RAI Volume 4, Chapter 2.5.3.2, First Set, Number 1: The following questions are related to Title 10 of the Code of Federal Regulations (10 CFR) Part 63, specifically, 10 CFR 63.21(c)(22).

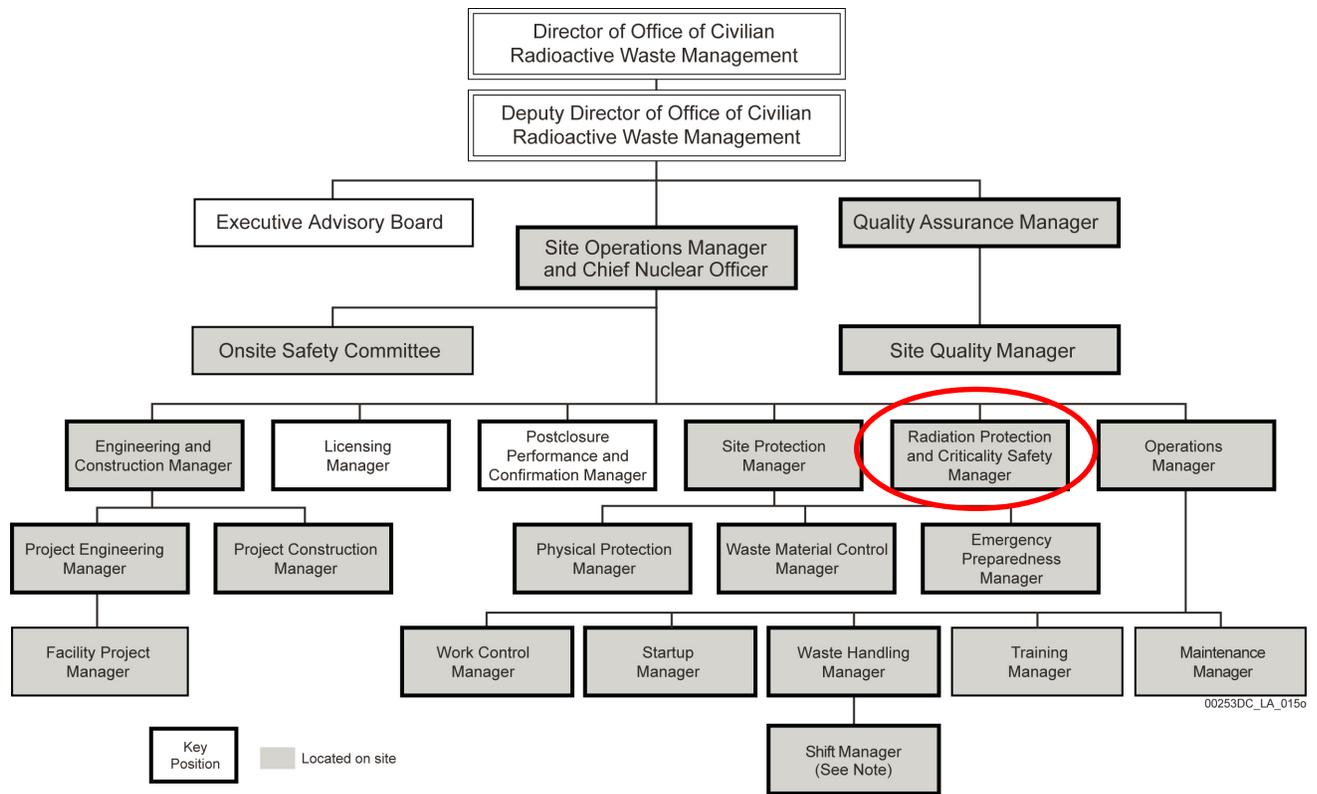
Explain how the organizational assignment of the Nuclear Criticality Safety Program (NCSP), as given in the proposed organizational chart (SAR Figure 5.3-1), is consistent with DOE's commitment to ANSI/ANS-8.19-2005, American National Standard, Administrative Practices for Nuclear Criticality Safety (as referenced in SAR Section 1.14.1). Specifically, explain how the NCSP is administratively independent of operations, and how the NCSP organizational functions and responsibilities are assigned in a manner consistent with those of other safety programs (such as Radiation Protection).

Alternatively, provide a revised organizational chart and explain the NCSP's organizational assignment, functions, and responsibilities, consistent with ANSI/ANS-8.19-2005.

The U.S. Department of Energy (DOE) has reviewed the organizational structure as shown in SAR Figure 5.3-1 and has decided that the proposed organization should be revised to improve the administrative independence of the Nuclear Criticality Safety Program (NCSP) from operations. The revised organizational structure will combine the Criticality Safety Manager functions with those of the Radiation Protection Manager and will be called the Radiation Protection and Criticality Safety Manager. This change will allow the NCSP to be administratively independent of operations and to function organizationally and to have responsibilities assigned in a manner consistent with those of other safety programs (such as Radiation Protection).

The Radiation Protection and Criticality Safety Manager will be at an equivalent level to the Operations Manager. Both managers will report to the Site Operations Manager and Chief Nuclear Officer. Reporting to the Radiation Protection and Criticality Safety Manager will be a Senior Nuclear Criticality Safety Specialist and a Senior Radiation Protection Specialist. Both specialist positions will require as a minimum, a bachelors degree in engineering, the physical sciences, or have equivalent technical experience. In addition, the Senior Nuclear Criticality Safety Specialist will have at least three years of nuclear industry experience in criticality safety. The Senior Radiation Protection Specialist will have at least three years of nuclear industry experience in radiation protection.

These organizational changes require revision to SAR Figure 5.3-1 and several SAR sections which currently describe the radiation protection and the nuclear criticality safety functions separately. The revisions to the organizational assignment, functions, and responsibilities, shown in Section 3 of this response are consistent with ANSI/ANS-8.19-2005 and the DOE commitment to the standard since they provide the NCSP with:

The DOE commits to revise the LA to reflect the change to SAR Figure 5.3-1 and associated text indicating the organizational structure shown in the attached figure. SAR Figure 5.3-1 and the text in SAR sections which describe the radiation protection and the nuclear criticality safety functions will be revised in a future LA update.

The DOE will revise Figure 5.3-1 as shown below.
